Access Compliance Report

(Curb Ramps)

Intersection ID: 7479	Main Street: COTTONWOOD_ST	Cross Street: JOE_ST	Location: SW
ADA ID: 73F57EA19121	Ramp Type: Perp	Initial Pass/Fail: Fail	Overall Compliance: No
Severity Score: 8.75			
Codes/Mitigation Info/Possible Solution		Field Measurements/Component Compliance

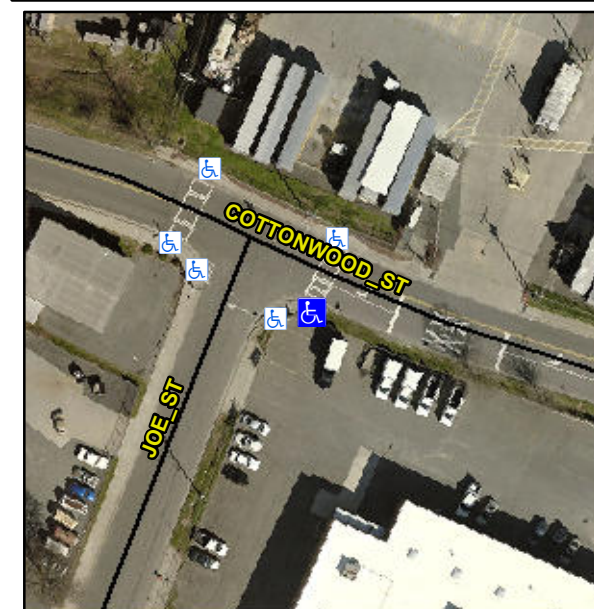
Not Found, R304.5.1

Compliance	Description	Data	Compliance	Description	Data
N/A	Ramp Length (in)	71.0	Yes	Ramp Slope (%)	6.6
No	Ramp Width (in)	47.0	Yes	Ramp XSlope (%)	1.6
N/A	Flare Type LT	N/A	N/A	Flare Type RT	N/A
N/A	Flare Slope LT (%)	N/A	N/A	Flare Slope RT (%)	N/A
N/A	Flare Traversable LT?	N/A	N/A	Flare Traversable RT?	N/A
N/A	Landing Length (in)	N/A	N/A	DWS Provided?	N/A
N/A	Landing Width (in)	N/A	N/A	DWS Contrast?	N/A
N/A	Landing Slope (%)	N/A	N/A	DWS Length (in)	N/A
N/A	Landing X Slope (%)	N/A	N/A	DWS Full Width?	N/A
N/A	Landing Curb? (Y/N)	N/A	N/A	DWS Offset (in)	N/A
N/A	Shared Landing?	N/A			
N/A	Gutter Ponding?	N/A	N/A	Gutter Slope (%)	N/A
N/A	Gutter Lip Ht (in)	N/A	N/A	Gutter X Slope (%)	N/A
N/A	Painted X Walk1?	Yes	N/A	Painted X Walk2?	N/A
	X Walk 1 Direction	To NE		X Walk 2 Direction	N/A
N/A	X Walk 1 Width (in)	114.0	N/A	X Walk 2 Width (in)	N/A
	X Walk 1 Slope (%)	6.5		X Walk 2 Slope (%)	N/A
	X Walk 1 X Slope (%)	0.2		X Walk 2 X Slope (%)	N/A

Remove & Replace Entire Ramp.
